AODE 4R70W

Precision International is pleased to announce the availability of PI # 37282. This gasket helps seal valve body cross leaks while using the early stiffener plate.

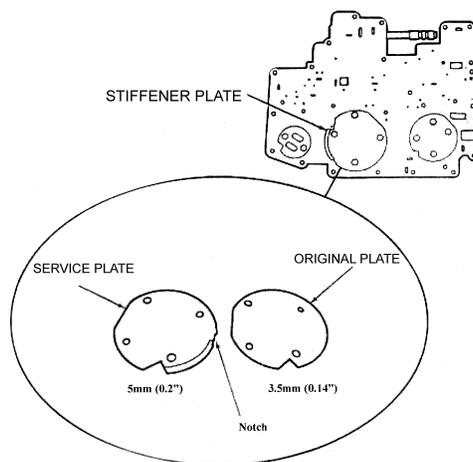
IN 1995 FORD INTRODUCED AN IMPROVED VALVE BODY STIFFENER PLATE TO REDUCE POTENTIAL CROSS LEAKS IN FORWARD AND REVERSE. THIS PLATE RETROFITTED ALL PREVIOUS MODELS. SINCE THIS IMPROVED SERVICE PLATE IS NO LONGER AVAILABLE FROM FORD, WE HAVE DESIGNED THE GASKET TO BE USED WITH THE ORIGINAL 3.5MM THICK PLATE TO PREVENT THE SAME CROSS LEAKS.

CAUTION: DO NOT USE THIS GASKET IF YOUR UNIT IS ALREADY FITTED WITH THE LATE 5 MM PLATE
